UNITED STATES PATENT AND TRADEMARK OFFICE

10/698,134

Office Action Summary	Application No. 10/698,134	Applicant(s) GENICK, RAYMOND M.	
	Examiner Leonard J. McCreary, Jr.	Art Unit 3616

DETAILED ACTION

Figure A. Bolt is fixed in angularly arbitrary horizontal position; 3-axis vertical mill with ball end mill used to machine channels having parallel faces.

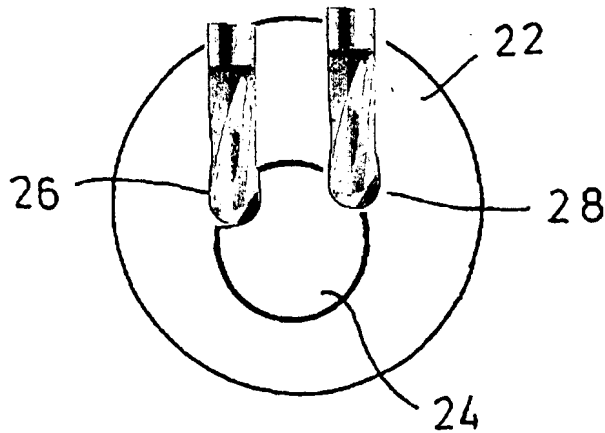
- a threaded fastener 1 defining a pair of longitudinal channels 18, 20, each channel defining a generally flat bearing surface and a concave curved portion, said generally flat bearing surfaces being generally parallel. (Figures 1-3, 6) (Figure A below) (col 4, lin 3-5)
- a non-threaded portion 10, 12 of the fastener 1
- a first cam plate 8 non-rotatably coupled to the non-threaded portion 10 of the threaded fastener 1
- a second cam plate 22 Figure 3 defining an aperture having a pair of generally flat aperture bearing surfaces, at least one generally flat bearing surface being in contact with at least one generally flat bearing surface, said aperture being non-rotatably mated to the pair of longitudinal channels 18, 20
- the rotational position of the first and second cam plates with respect to each other is fixed (col 1, lin 36-40) (col 2, lin 5-7)

Examiner maintains that the rejection is proper, because it would have been obvious to one of ordinary skill and creativity in the art to construct the cam assembly taught in Fig 3 of Hofschneider similarly to that which is claimed in the present application, so as to improve manufacturability by machining the channels with a ball end mill on a standard 3-axis mill with the bolt fixed in a single horizontal position and wherein angular orientation of the channels about the longitudinal axis of the bolt becomes irrelevant.

See Fig. A below.
